### ADDENDUM #3

Project Number: DRC070124

**Medical Infirmary Addition - Franklin Pre-Release Center**

JISA 08579.00

Parapet Detail @ Existing Bldg.

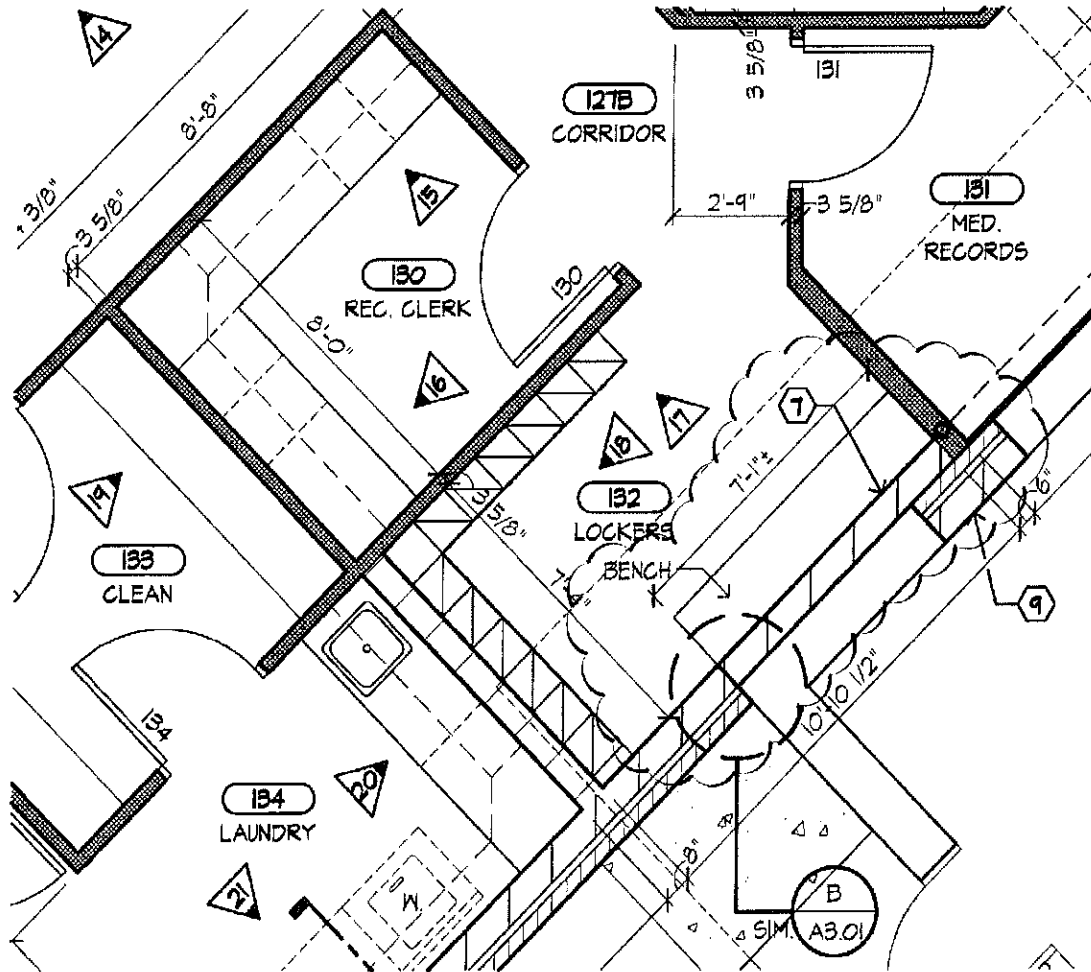
Item #2 Sheet A7.01, Detail E. See attached revised detail E/SK.05 to replace E/A7.01. Galvanized ledge angle, L 5" x 5" x 5/16" to be bolted to solid grouted masonry with 3/4" diameter expansion bolts at 24" o.c.

**First Floor Dimensioned Plan**

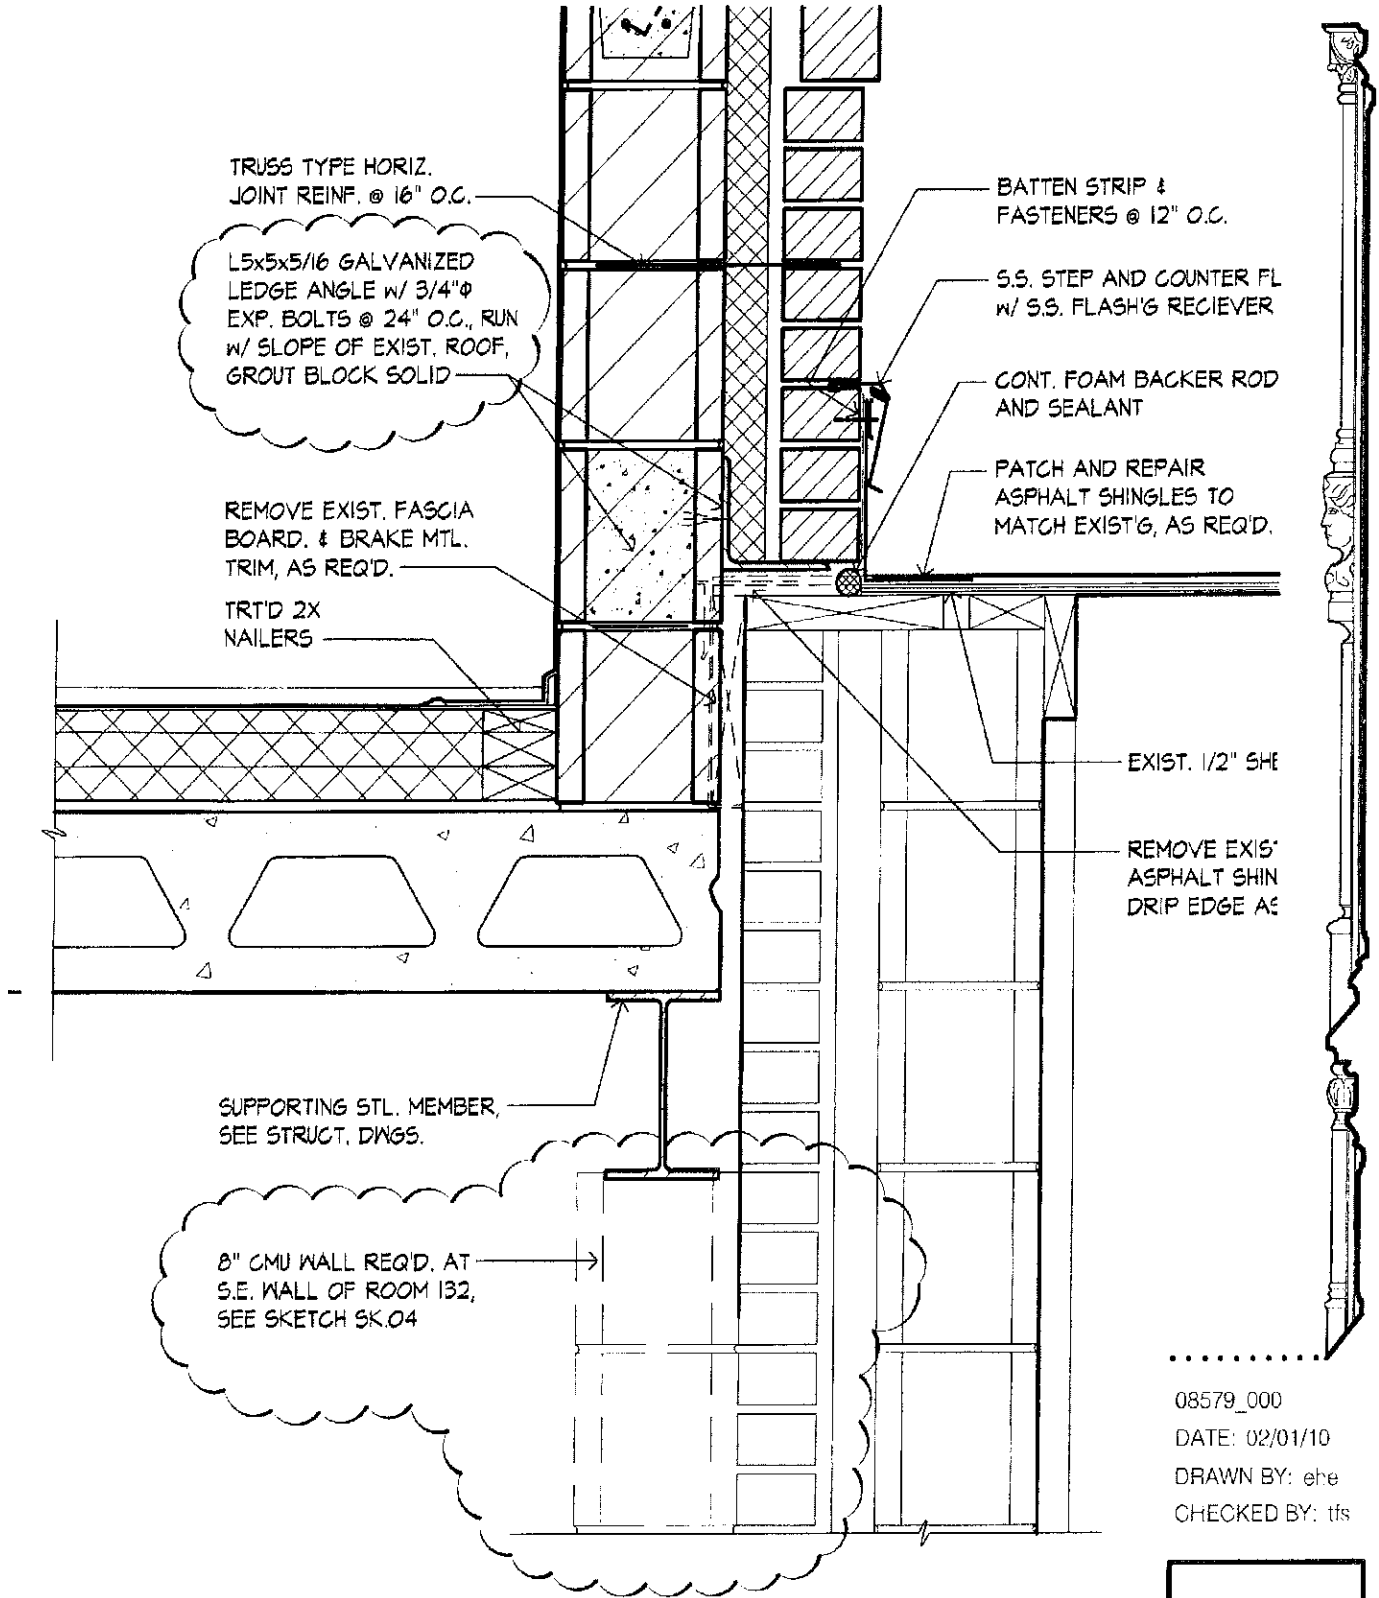
Item #1 Sheet A1.02. Extend concrete masonry wall through Locker Room 132 to column at coordinates Y/X2. See Structural Drawings. Wall to extend to underside of W8 x 21 beam above; top of beam elevation +110'-8". Extend footing beneath wall to match Detail C/S2.1. See Attached Sketch SK.04.

⑦ EXTEND 8" CONCRETE MASONRY TO POST 'Y/X2'. EXTEND MASONRY TO UNDERSIDE OF WB BEAM ABOVE.
